UNITED STATES PATENT AND TRADEMARK OFFICE

APPLICATION NO.	FILING DATE	FIRST NAMED INVENTOR	ATTORNEY DOCKET NO.	CONFIRMATION NO.
10/824,116	04/13/2004	Tomonari Itou	FP04-017US	6449
1218	7590	02/23/2005	EXAMINER HARVEY, JAMES R	
CASELLA & HESPOS 274 MADISON AVENUE NEW YORK, NY 10016			ART UNIT 2833	PAPER NUMBER

Office Action Summary

DETAILED ACTION

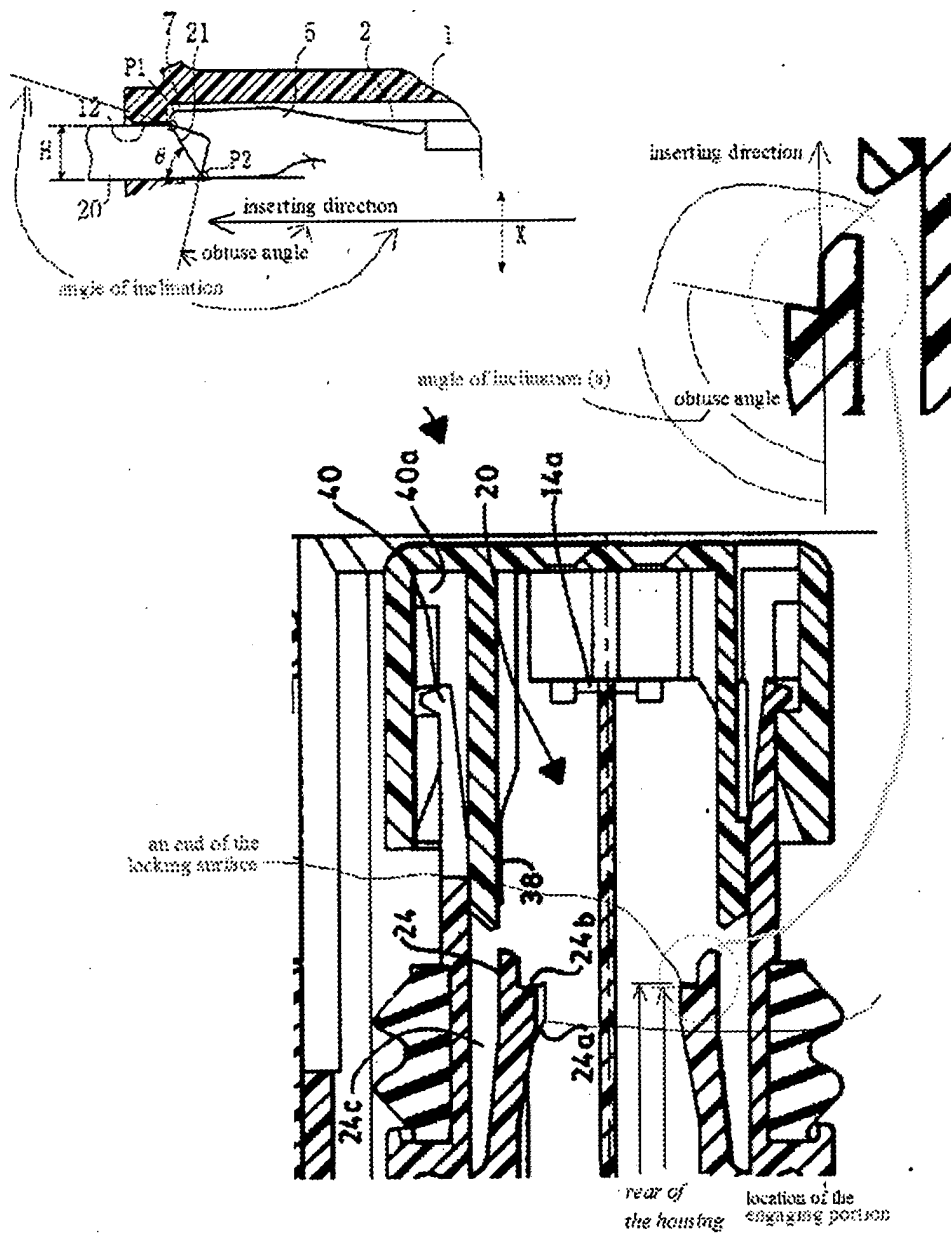
the locking surface 24b of the lock 24 being slanted to form an obtuse angle (a) with respect to the inserting direction (see examiner's figure).

lock 5 engages an engaging portion 4 (cover sheet) of the terminal fitting 3 for locking the terminal fitting 3 so as not to come out,

the locking surface (near the lead line of numeral P2 (figures 3C)) of the lock 5 being slanted to form an obtuse angle (see examiner's figure) with respect to the inserting direction.

-- In reference to Claim(s) 7, Yamanashi shows the disengagement operable portion (near the lead line of numeral P1 (figure 3B) is inclined with respect to the inserting direction and has a greater angle of inclination than the angle of inclination of the locking surface (near the lead line of numeral P2 (figure 3C)).
